Review of Fuel Tank design at Goose Lake mine site, Back River Project

KIA review of fuel tank.pdf

Map is provided by Sabina.

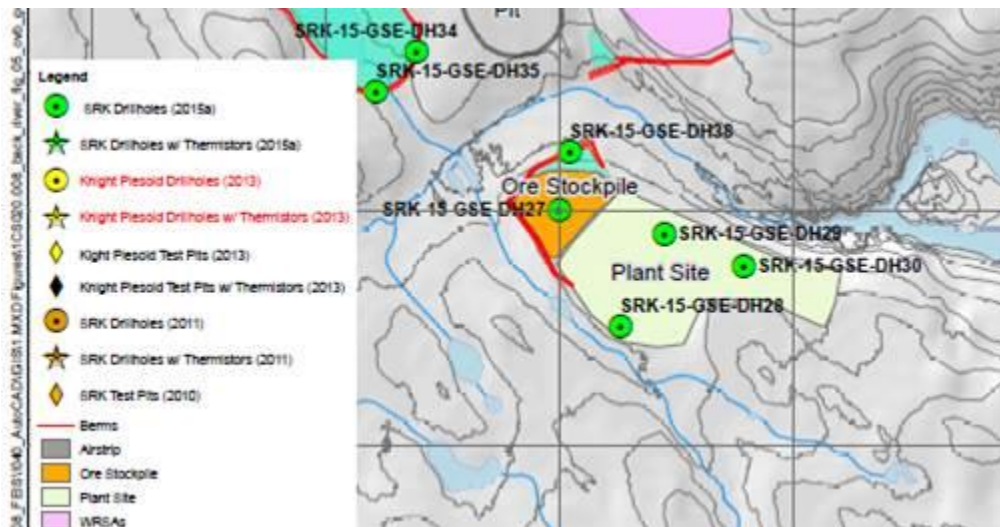
boreholes per site. This standard is not binding for tank foundations, so it is really up to the developer what to do.

Sabina has numerous geotechnical holes in the Plant Site Area and specifically in the Fuel Storage Area at Goose collected during the original EA and Water Licensing Phase and in the years since. I will ensure this information is included in future applications. I have attached a map which illustrates the geotechnical holes drilled in 2017 – you will note there is one hole (17GGT012) directly on top of the 10ML fuel tank, 1 more directly in the in-Fuel Storage Area, and 2-3 more in the nearby vicinity. Below is also a snip from the Back River Property Geotechnical Design Parameters Report submitted during the original Type A Water Licence Application (171002 2AM-BRP---MAD App F-2_GeotechDesignRpt-IMLE) which illustrates additional geotechnical drill holes completed in 2015.
